**Technical Bulletin**  
**No. AF-001**Issued on  
January 16th, 1992**Subject:**  
**Pulse width setting****Model(s):** AF0/AF2FAX T.S. Section T.S. Department  
Assistant General Manager  
H. Motojima**Classification**

This is additional information for the service manual.

**Technical Bulletin**  
**No.AFO-004**Issued on  
April 23rd, 1992**Subject:**  
**Modification of cutter unit****Model(s):** AFO/AF2FAX T.S. Section, T.S. Department  
Assistant General Manager**Classification**H. Motojima

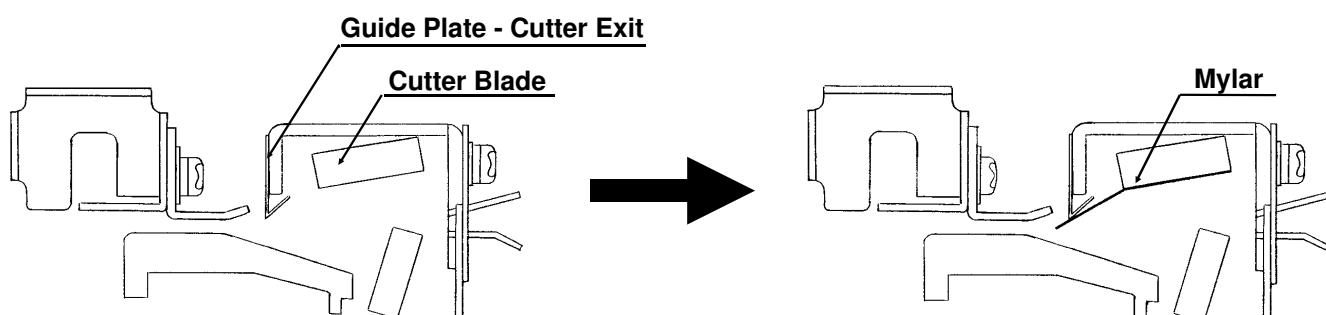
The design section tested the machine under abnormal conditions (They tested 4 units of AFO after adjusting the clearance to the widest.)

The result of testing is shown below.

We guess that paper jams caused by this tolerance problem would occur rarely, according to the test result.

Also, the frequency should almost be within the specification (less than 1/1000).

However, if paper jam occurs in the field, and if the guide plate of the cutter exit is not used in the cutter, you should attach the guide plate to the cutter or attach the spacers between the feed-out roller holder and the feed-out guide plate.

[Diagram A]

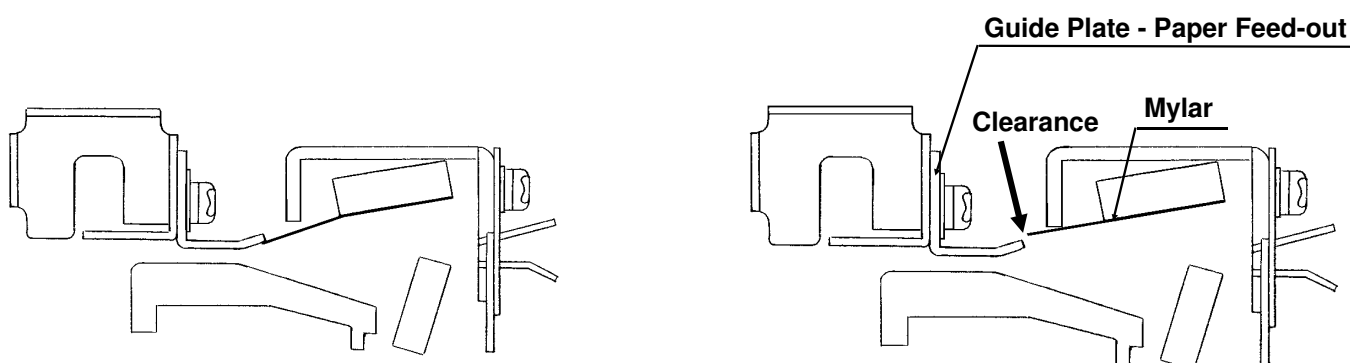
From the July, 1991 production, to prevent from paper jam at the cutter exit, a mylar has been attached to the cutter blade (Diagram A).

[Diagram B]

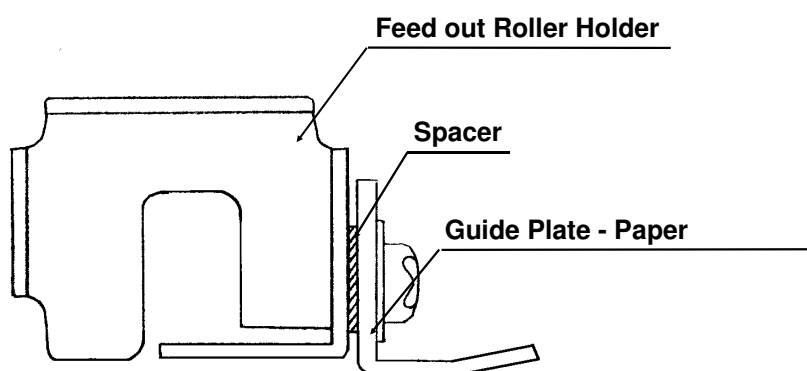
With this modification, the guide plate of the cutter exit was discontinued after the old cutter assembly was out of stock (Diagram B).

This discontinuance has been applied from the February, 1992 production.

However, we found in the production line that few machines experienced paper jam due to the discontinuance of the guide plate.

The guide plate of the cutter exit has been reattached.
